# Crystal Vestiti Ltd.

31 July 2023

# Observations

# **Foundation on expansive soil & ground bearing capacity consideration in the design report**

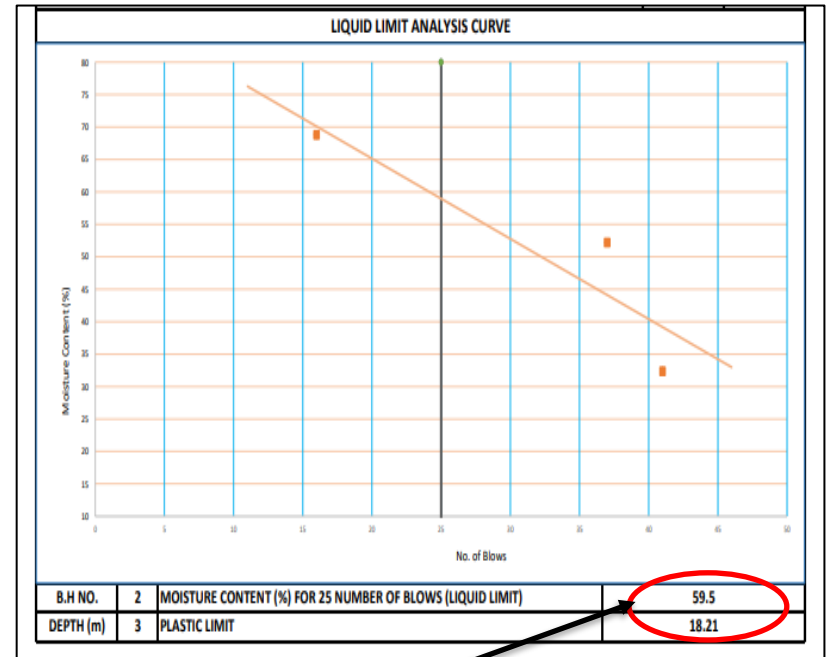
The building is standing on three different types of shallow foundations.

Foundation rest on fat clay (CH) and Liquid Limit is greater than 50 which indicates possibility of expansive behavior of the soil. There are some low land water bodies nearby the building.

The building engineer is required to carry out further investigation for the expansive soil and incorporate the result in the design report. Suggest remedial measure accordingly.

# Mismatch and lack of as-built drawing

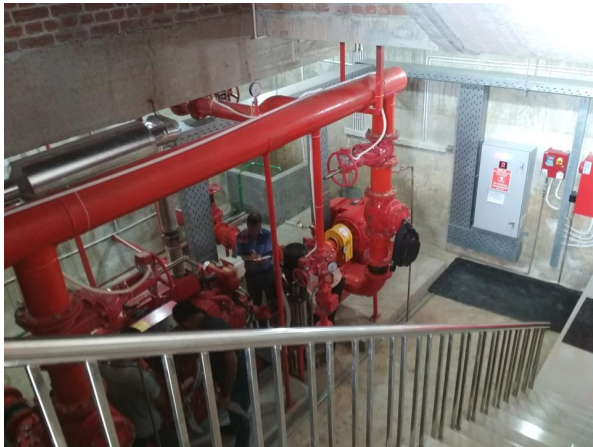
Beam on site: 900 mm depth

As built drawing: beam depth 600 mm

The building engineer is required to update as-built structural drawing as per site condition.

Over stress column in design report:  
PMM>1.0

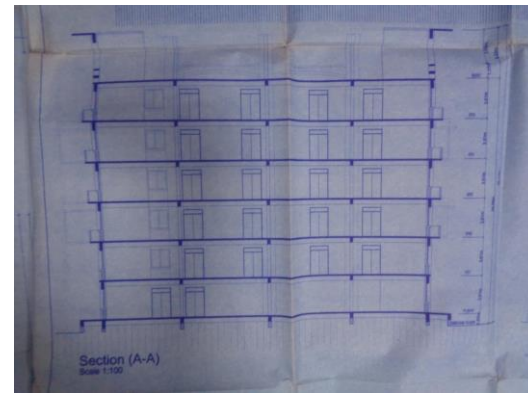
**Column stress exceeds normal design  
limit considering possible vertical extension**

Building-1 was permitted for proposed 6 storey

Extended column on roof indicates future vertical extension of the building.

For proposed 6 storied building, considering design strength of concrete, some of the columns were found over-stressed. Prior to vertical extension, the building engineer is required to revise Detail Engineering Assessment (DEA) for the proposed building.

Brick wall layout: 250 mm brick walls

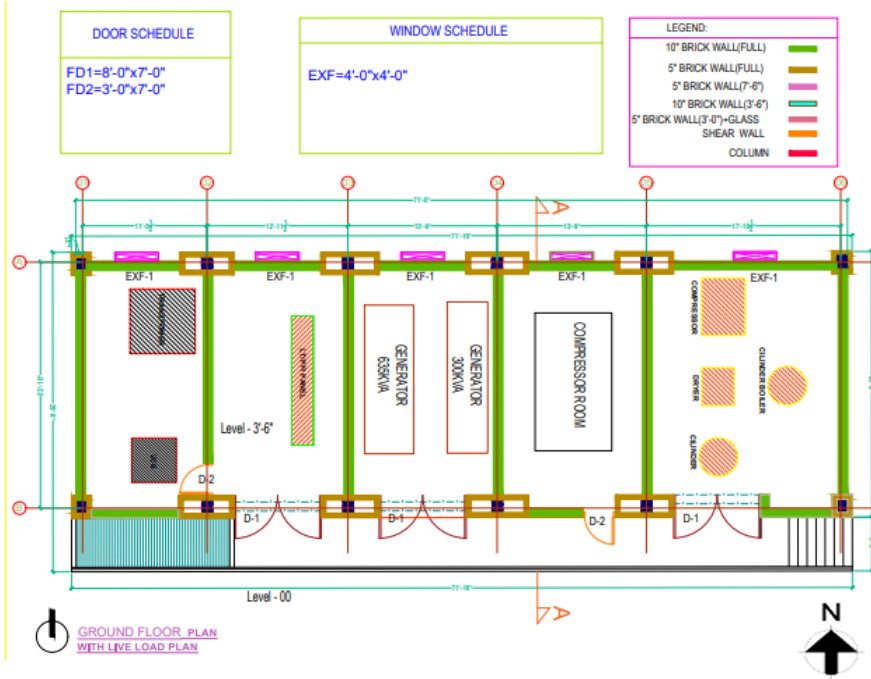
**Brick wall load missing in the analysis**

There were 6m high 250mm brick walls on the beams which was not considered in the finite element analysis (FEA) model. The column height was 6m and size was 300mm x 375mm. The building engineer is required to consider wall loads & slenderness effect of column in the analysis and update the FEA model & design report accordingly.
